Submittal #055000-7.R2 055000 - Metal Fabrications

Project: 1386 - Signature at West Pryor
2100 NW Lowenstein Dr.
Lee's Summit, Missouri 64081

Carport Shop Drawings

DESCRIPTION	REMARKS
055000-7-r2 carport shop drawings	REVIEWED
BDC SHOP DRAWING STAMP COMMENTARY <p>This review was performed only for general conformance with the design concept of the project and general compliance with the information given in the contract documents. Modifications or comments made on the shop drawings during this review do not relieve the contractor from compliance with the requirements of the plans and specifications. Approval of a specific item does not include approval of the assembly of which the item is a component. Contractor is responsible for: dimensions to be confirmed and coordinated at the job site; information that pertains solely to the fabrication process or to the means, methods, techniques, sequences, and procedures of construction; coordination of the work of all trades; and for performing all work in a safe and satisfactory manner.</p> <p style="text-align: center;">DEFINITIONS</p> <p>APPROVED Submitted materials appear to satisfy design intent if installed using specified materi

COLUMN TO BEAM CONNECTION

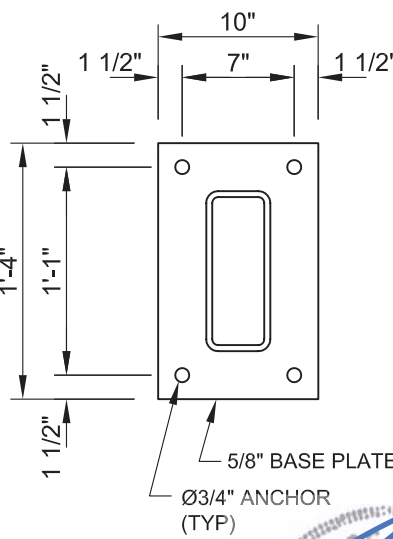
NAME	SENT DATE	DUE DATE	RETURNED DATE	RESPONSE	ATTACHMENTS	COMMENTS
General Information Attachments					055000-7-R2 Carport Shop Drawings - 3.9.23.pdf	
Clark Basinger	03/09/2023	03/10/2023	03/09/2023	Approved as Noted	055000-7-R2 Carport Shop Drawings - 3.9.23.pdf (Current)	designer should specify member connections
Michaela Silva	03/09/2023	03/13/2023	03/21/2023	Approved
